NRI 420240850 and Concept Plan #520240040, 9312 Persimmon Tree Road

NRI 420240850 Review

NRI 420240850, V4

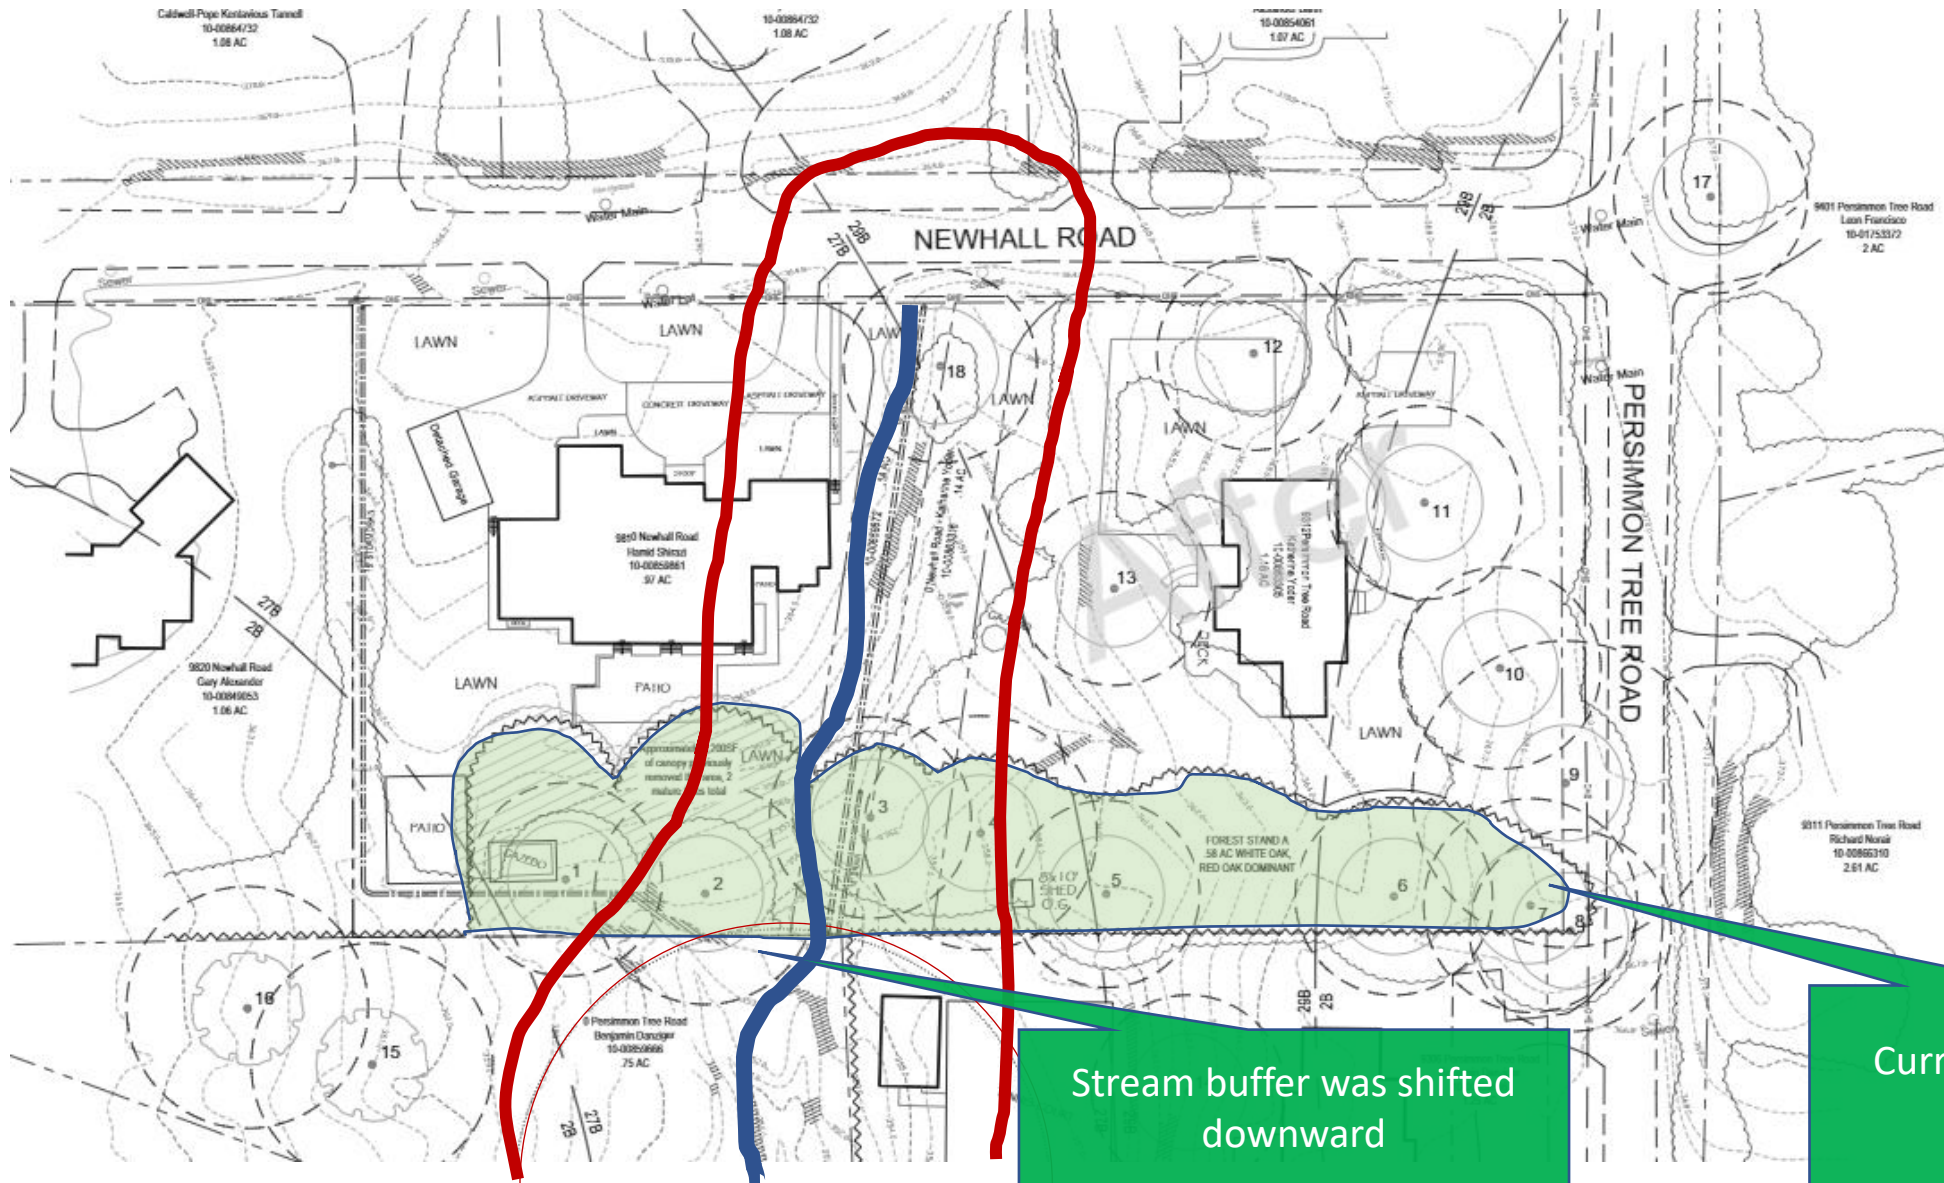
Ref.# 110	Changemark note #01	AREA ENVIRONMENTAL	Ariel Zelaya	11/20/23 2:49 PM	Cycle 1
	Unresolved		01-NRI-420240850-001.pdf			<div>Verify</div> 
	Markup		All streams/wetlands and associated buffers located on or within 200 feet of the subject property must be shown on the NRI/FSD summary map. Address the hydrologic features in the plan view and universally update all graphics, notes, tables, and figures accordingly.

Please show an intermittent stream and its associated buffer within the study area. All streams/wetlands and associated buffers located on or within 200 feet of the subject property must be shown on the NRI/FSD summary map. Or, please present an official letter from the MDE stating that the stream is not part of the Waters of the U.S. and is an ephemeral stream for consideration.

Other adjoining properties to the south also have the same natural channel running along their boundaries, and the NRI/FSDs have identified it as a stream and stream buffer. Please review the files 42010200E, 42021194E, and 42011034E for more information.

*Red line (Stream buffer) is currently not being shown by the applicant.

*Blue line (Stream), just for reference) is currently not being shown by the applicant.

Stream buffer was shifted downward

MDE letter provided with this submission and buffer shown.

Stream added to portion of 9810 Newhall Road. No buffer was added. Please reference M-NCPPC Montgomery County Planning Department Environmental Guidelines - Stream Buffers on page 5. Please note that this property is not in the Ten Mile Creek Watershed. "In most of the County, ephemeral streams do not require a stream buffer, but these streams should be protected as much as possible through plan layout and conditions on a voluntary basis."

Ephemeral stream head is located on adjacent property 0 Persimmon Tree Road directly south of 9810 Newhall Road property. Storm drain pipes discharges to this stream head through subject property study area shown on plan. Per Montgomery County Environmental Guidelines, no buffer is required for ephemeral streams in this watershed. Previously approved NRI 42021194E shows this stream location as well.

Official letter from the
MDE

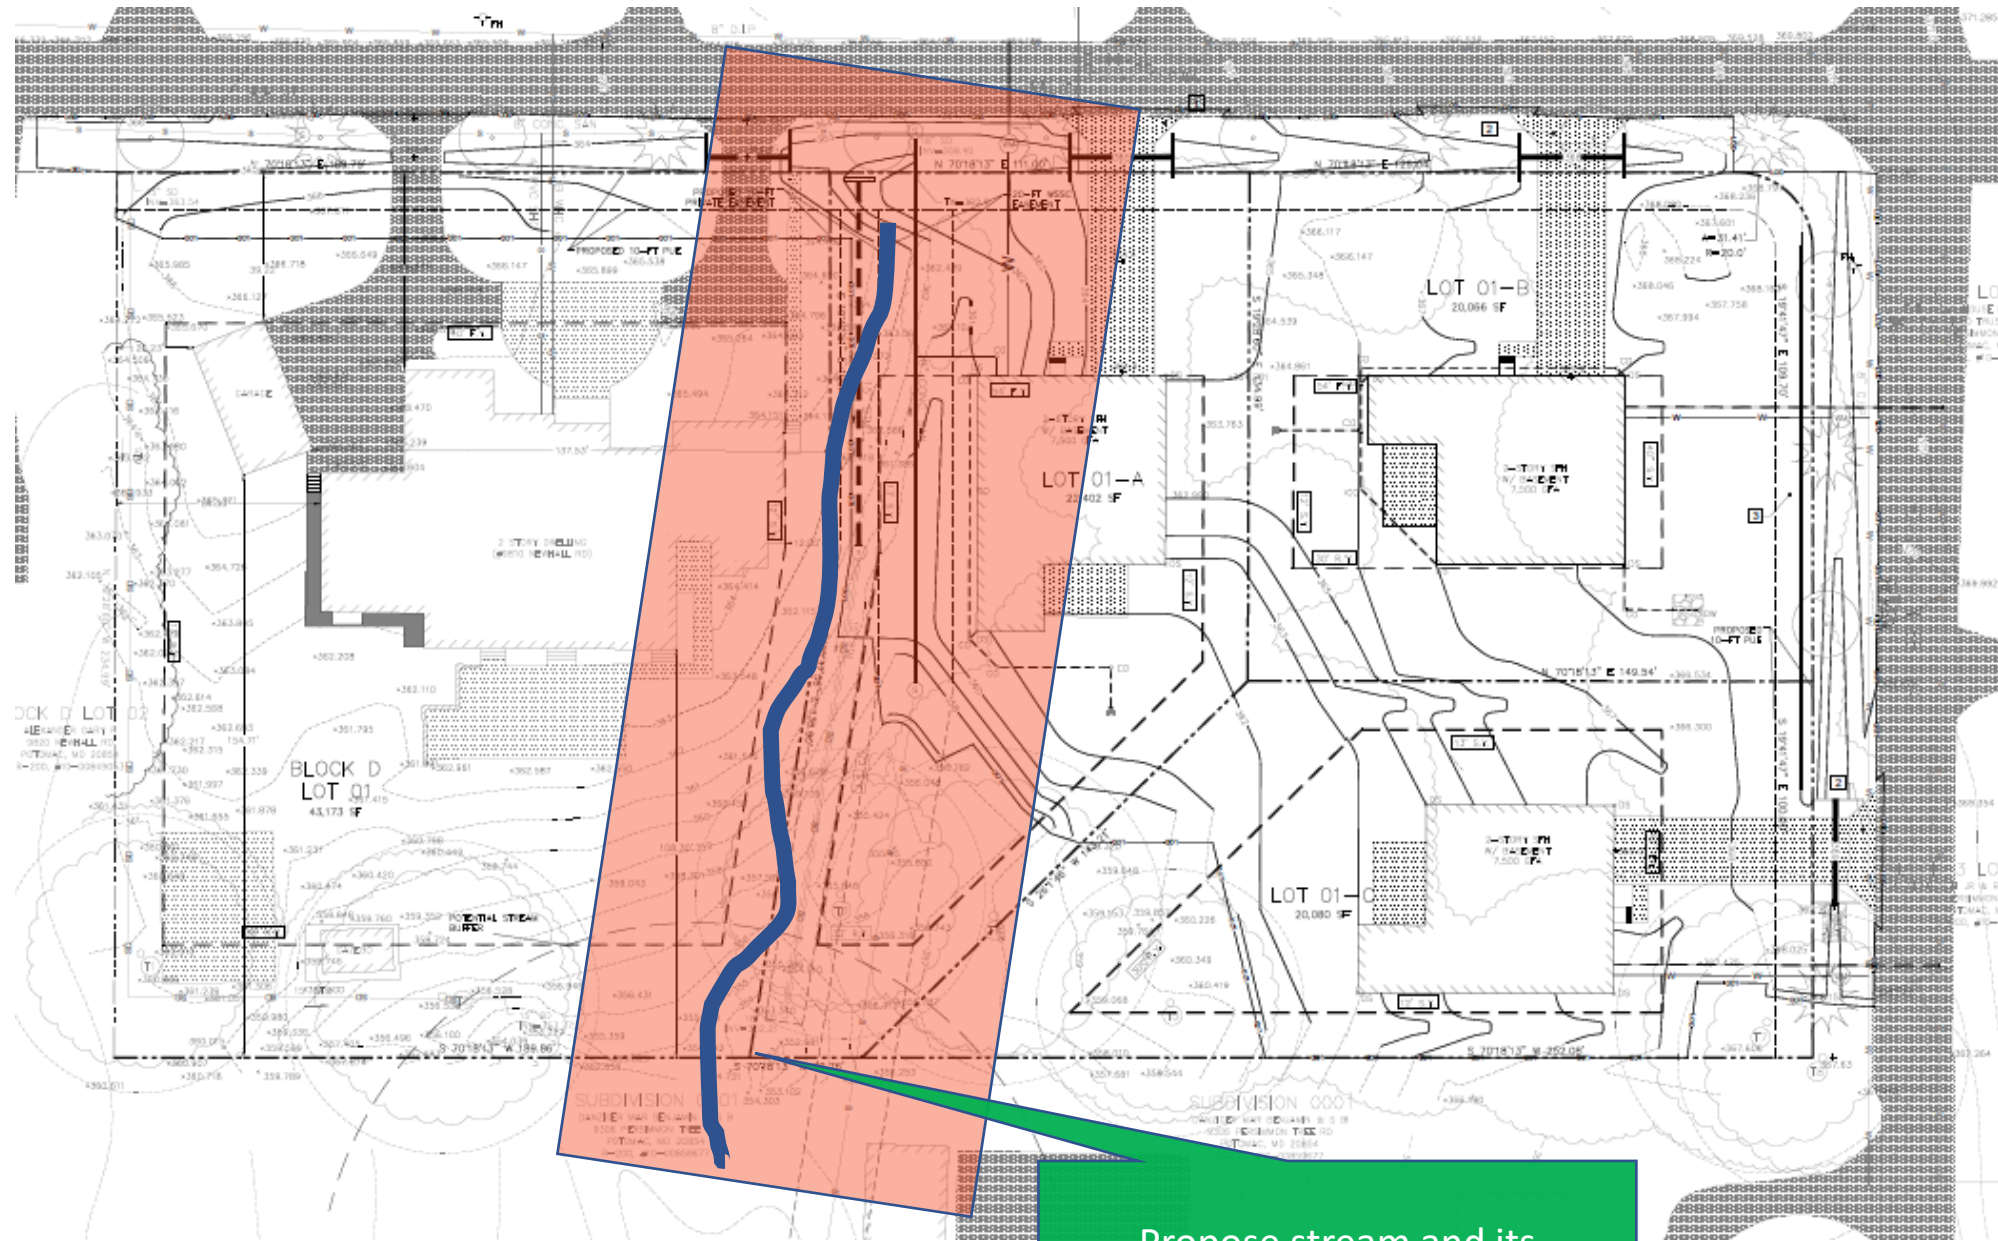
Field data, documentation (video and pictures), and Forest Conservation Plan Exemptions have confirmed the presence of previous critical environmental features such as a stream and the associated buffer that were recently disturbed on the subject property. Topographic, hydrologic, and soil maps, Geographic Information Systems (GIS), and fine-resolution Light Detection and Ranging (LIDAR) have also been used to verify the extent of the stream and forest that have been disrupted. The provided Letter from the MDE will not be considered for this plan. Therefore, remove the letter from the plan.

In order to comply with the Forest Conservation Law Chapter 22A, Trees Approved Technical Manual 1992, and the Environmental Guidelines for Management of Development in Montgomery County 2021, the applicant must address the previous comment to fully represent previous and current field conditions (the applicant must show the stream and its associated buffer) and other relevant environmental features for the Natural Resource Inventory/Forest Stand Delineation (NRI/FSD). By failing to address the standard requirement for the Natural Resource Inventory/Forest Stand Delineation (NRI/FSD), the plans cannot be approved.
